Subject: Submittal of the Response to the Notice of Disapproval for the Investigation Work Plan for Upper Sandia Canyon Aggregate Area and Revision 1

Cross-Reference of NMED NOD Comments and Revisions to Upper Sandia Investigation Work Plan

Figure 4.1-28 Map G proposed sampling locations

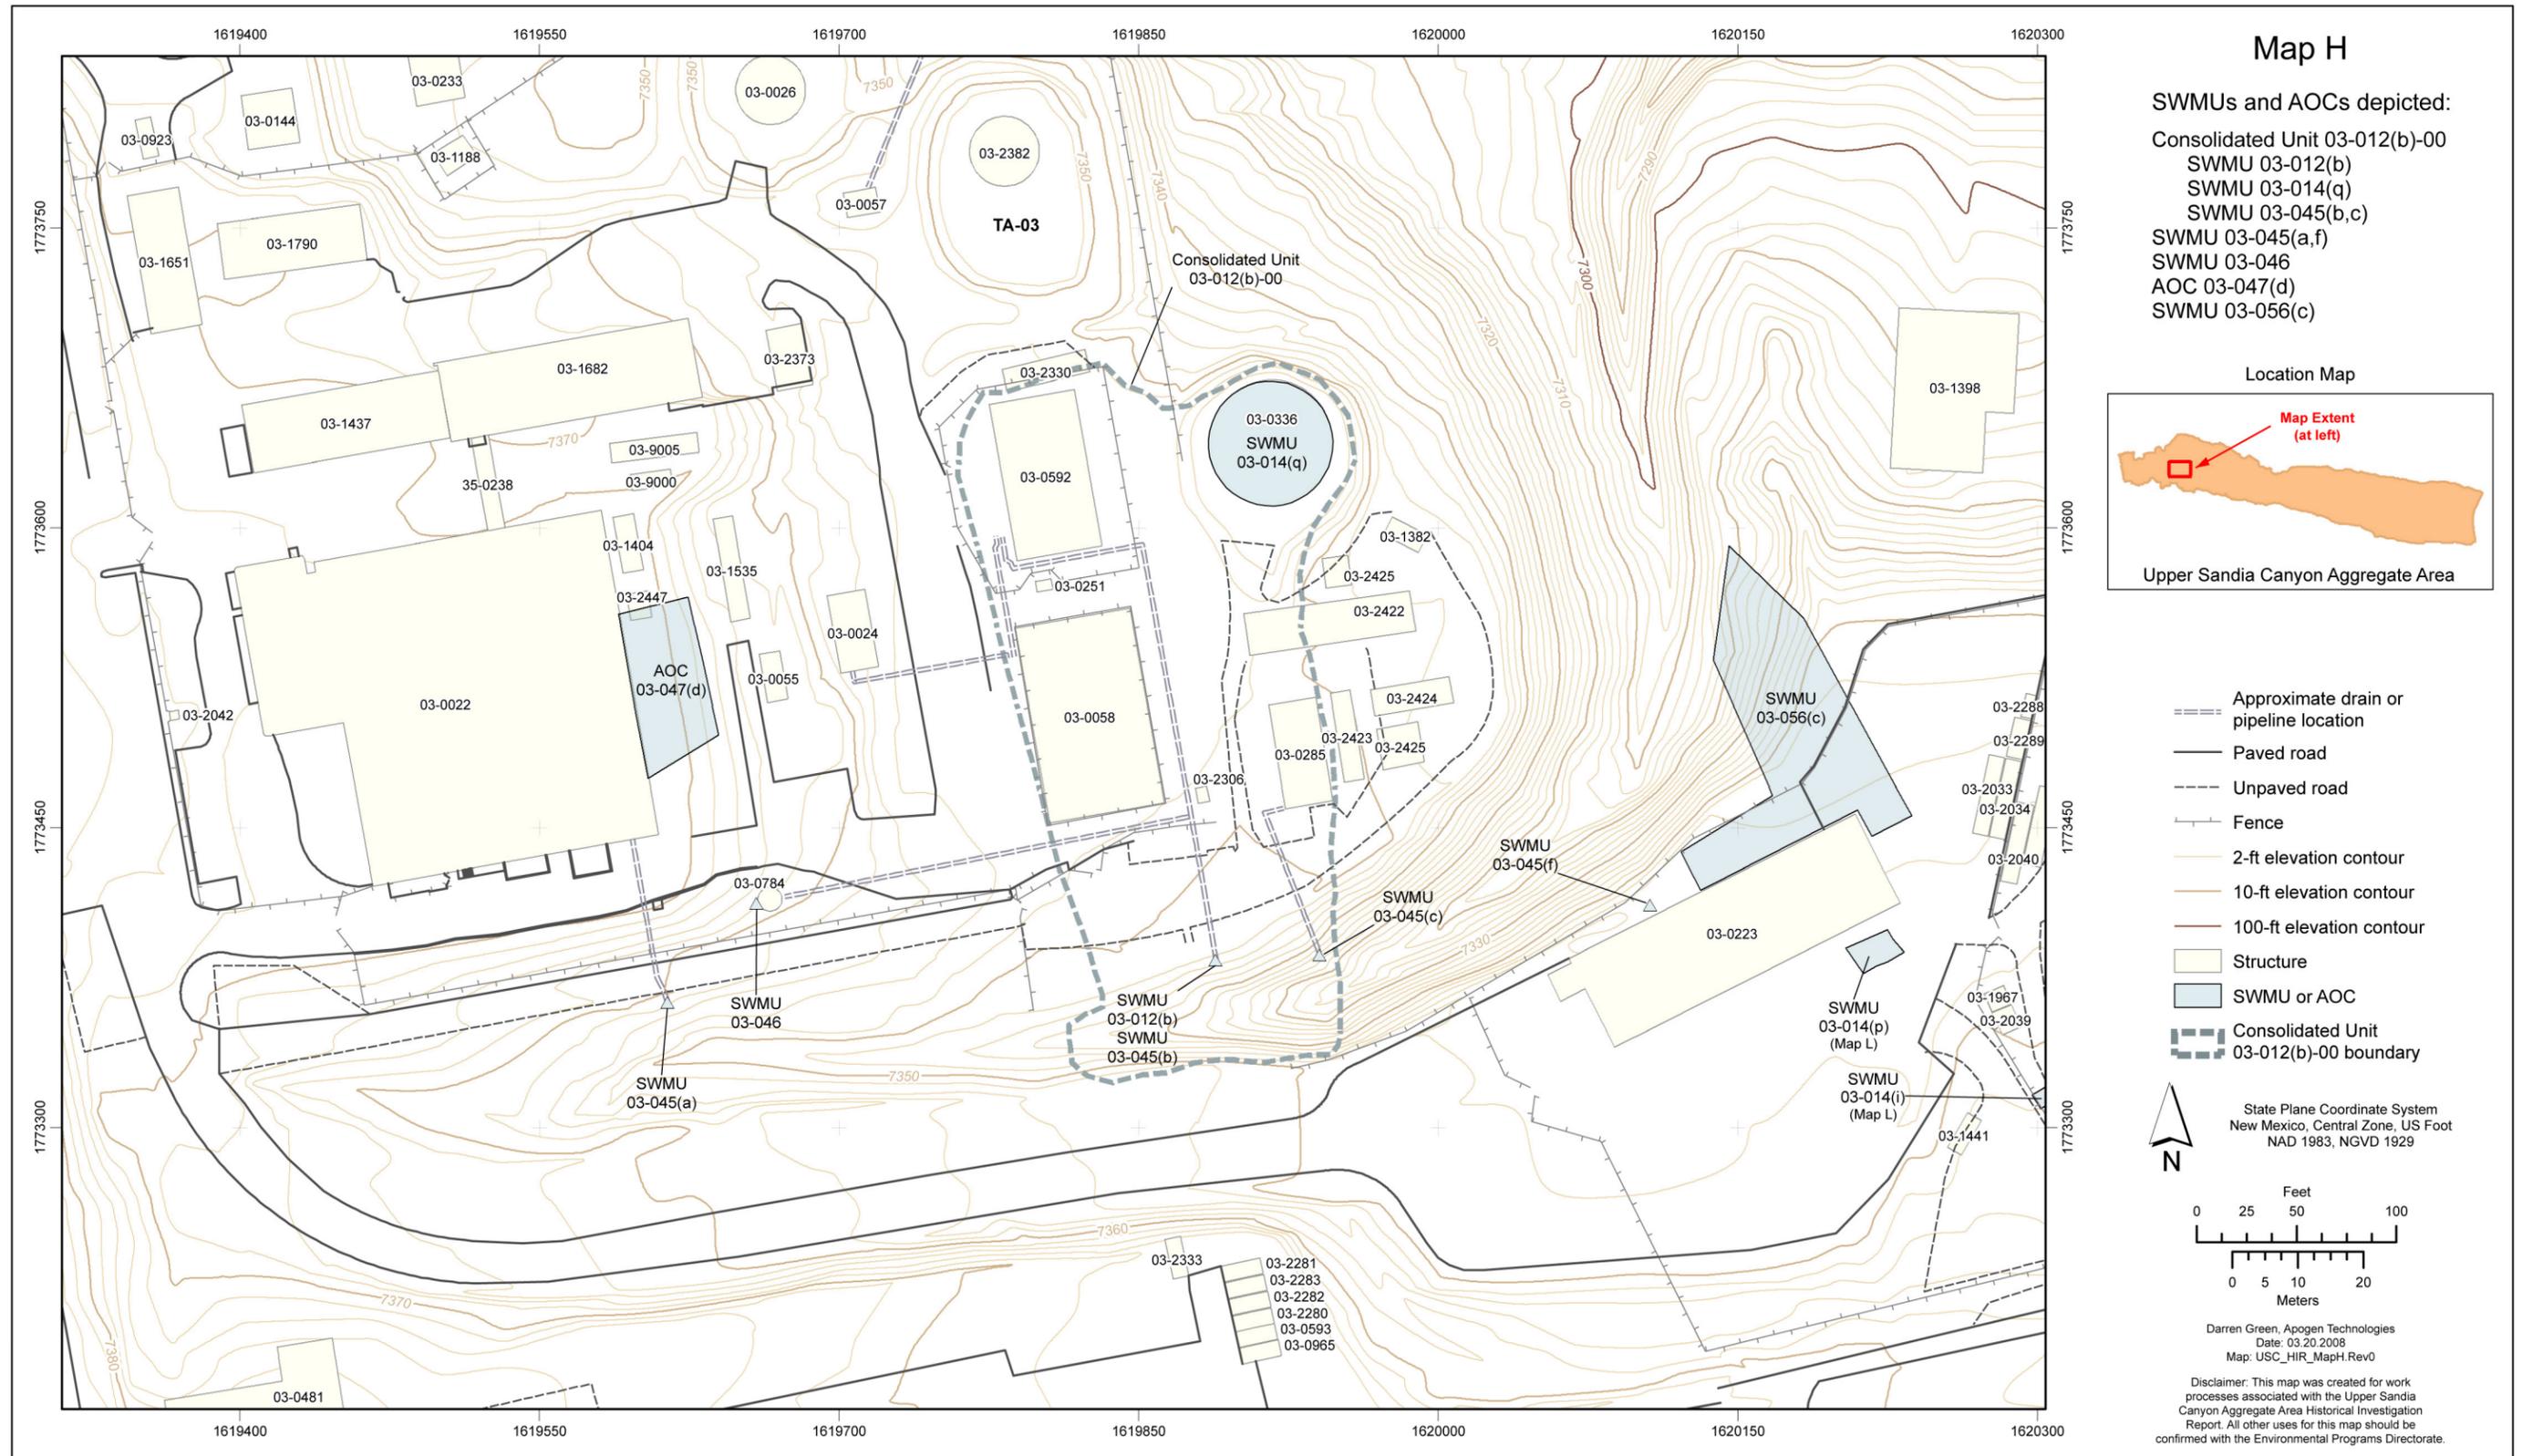
The Permittees must sample the drainage(s) associated with the site from the top of the slope to the toe of the colluvium. It is not clear from the Figure 4.1-28, if the Permittees propose to collect samples along the entire length of the drainage to the toe of the colluvium. The Permittees must revise the Figure to depict the proposed sampling locations (see General Comment # 3). In addition, under the Proposed Activities, the historical sampling location should be 03-03331, not 03-0331; correct the typographical error.

19. Figure 4.1-28 has been revised to show the drainage below the SWMU 03-021 outfall. The proposed sampling locations were modified to include the drainage to the northeast of the outfall. Samples collected for AOC 03-014(b2) in the same drainage will also be used to determine the nature and extent of contamination for this site (Figure 4.1-48). The text in section 4.1.20 has been revised to correct information on the historical sampling location.

Figure 4.1-44 Map L site location

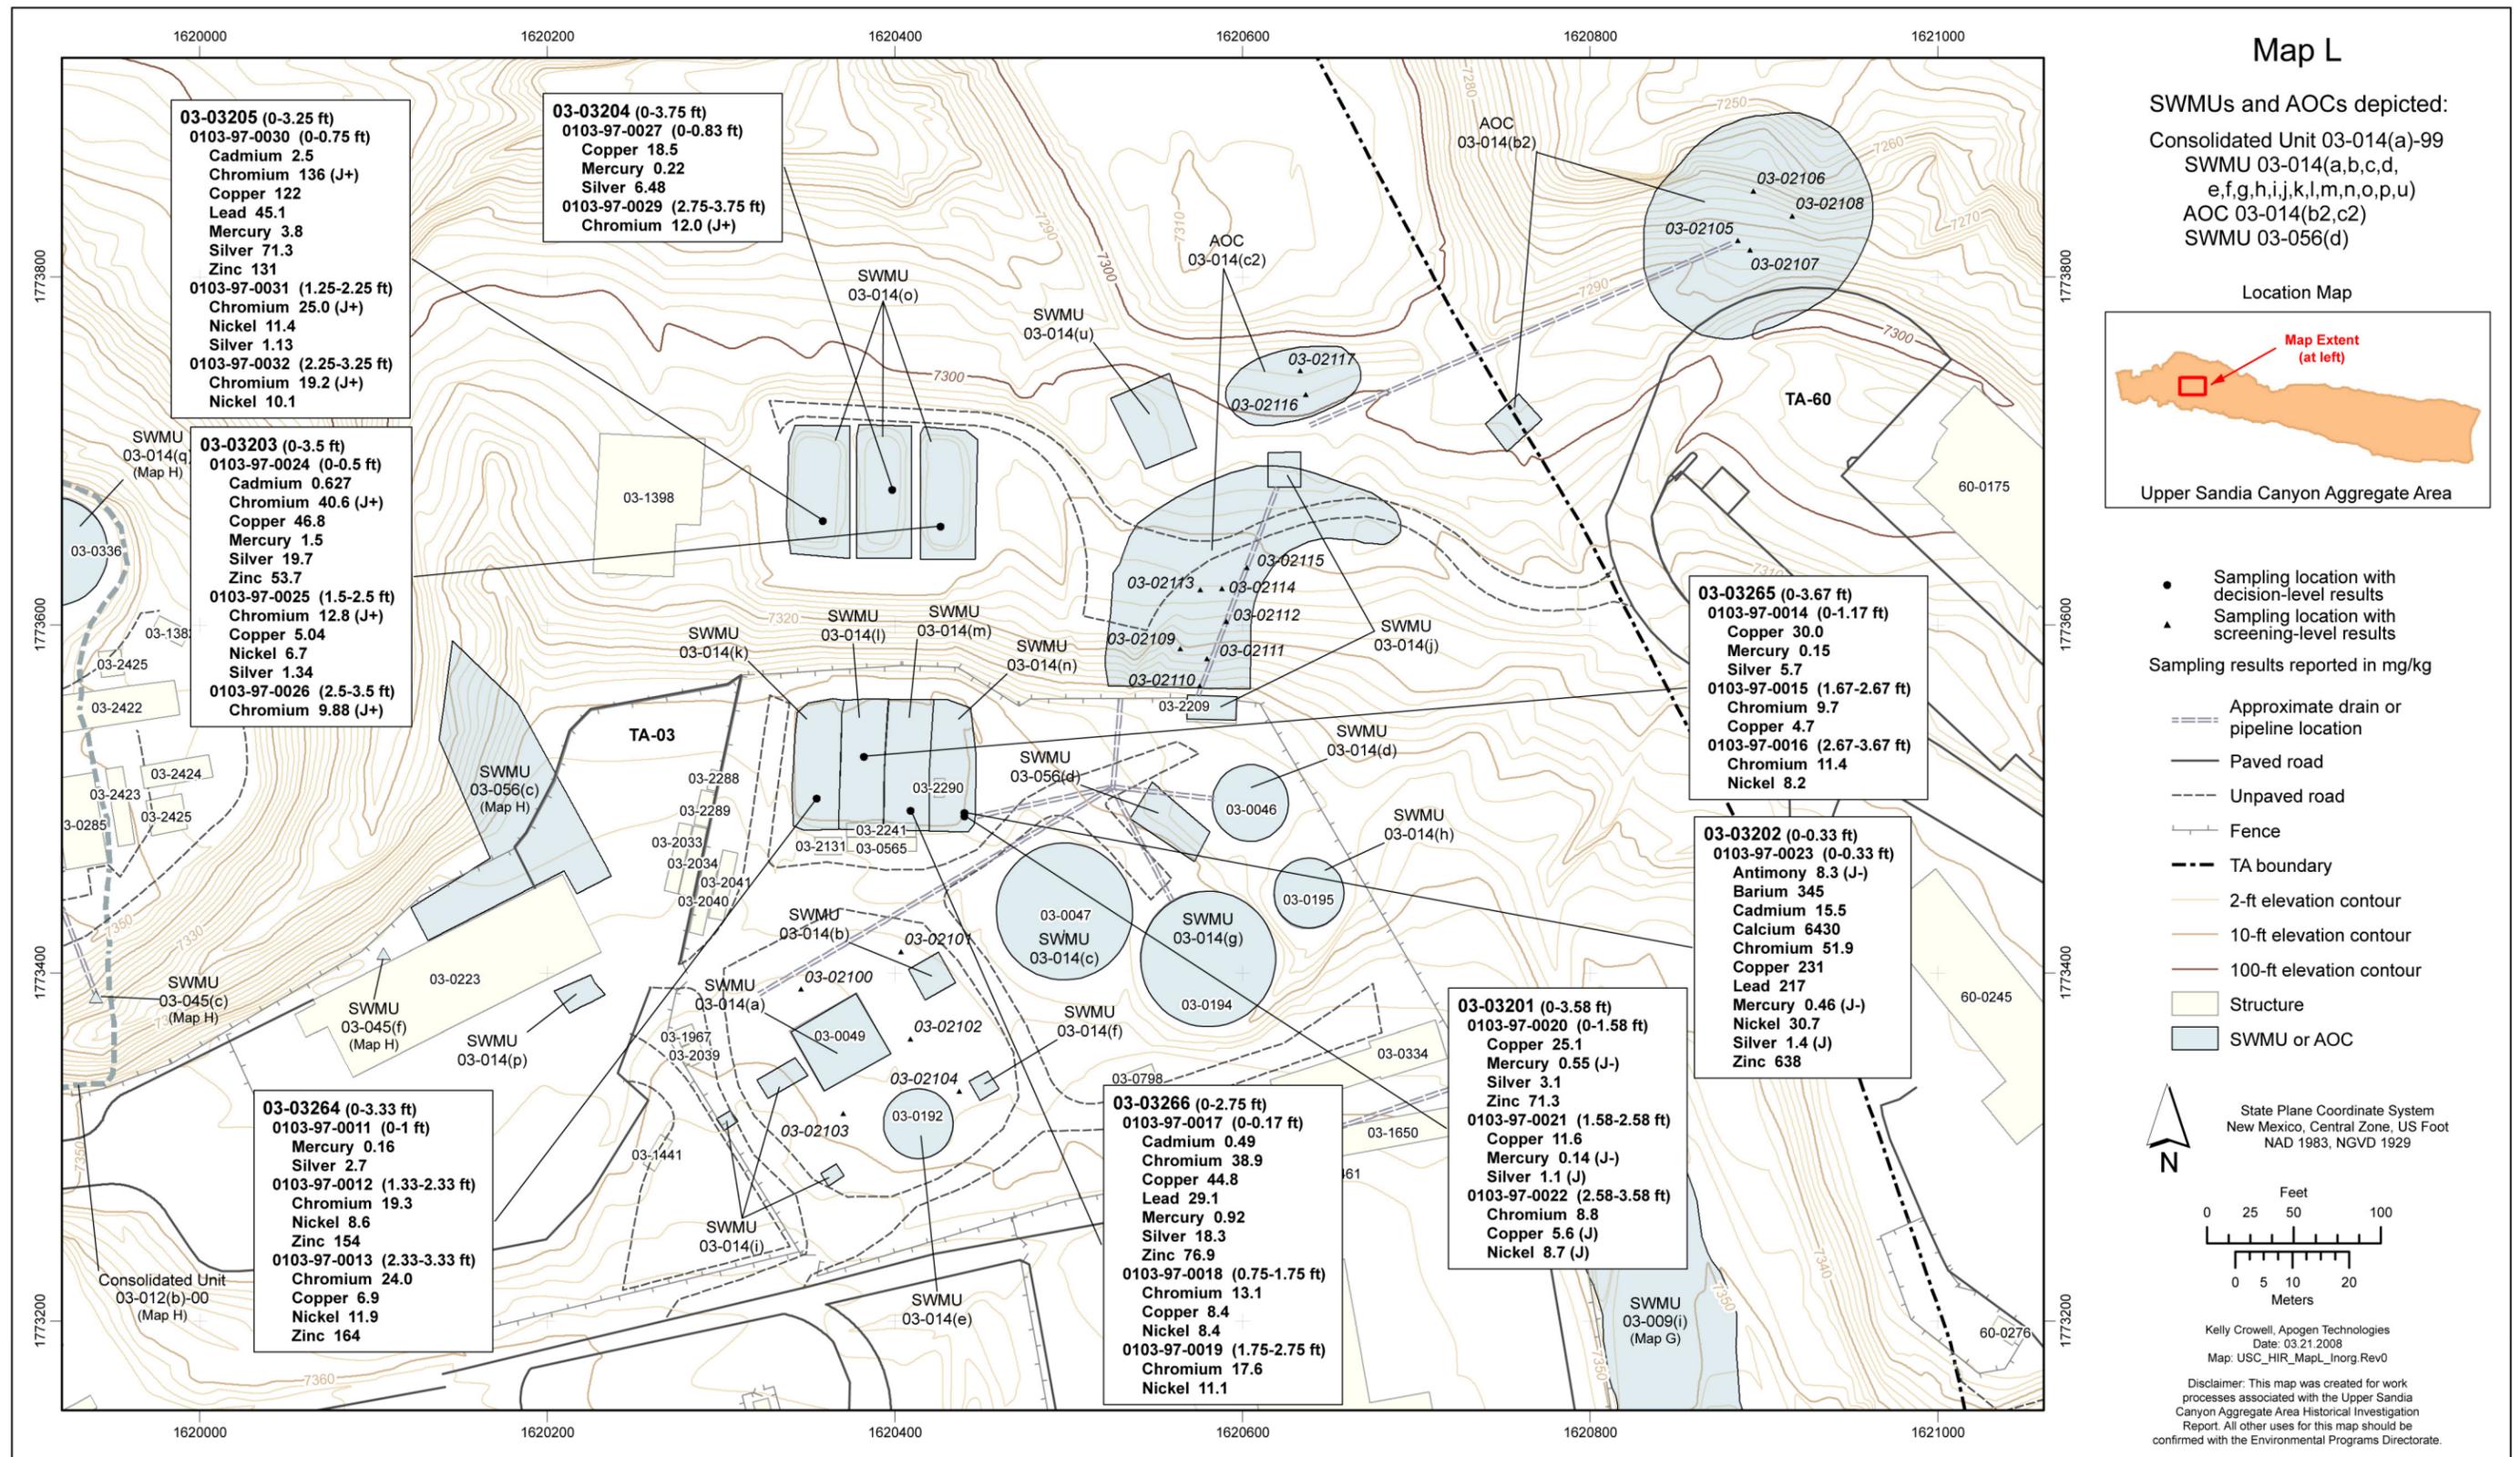
In Figure 4.1-44, structure 03-0194 is designated as SWMU 03-014(g), not structure 03-0047, as stated in the text. Resolve the discrepancy and revise the figure or text accordingly.

12. Figure 4.1-44 is correct: structure 03-0194 is designated as SWMU 03-014(g). The text in section 4.1.13.9 has been revised accordingly.
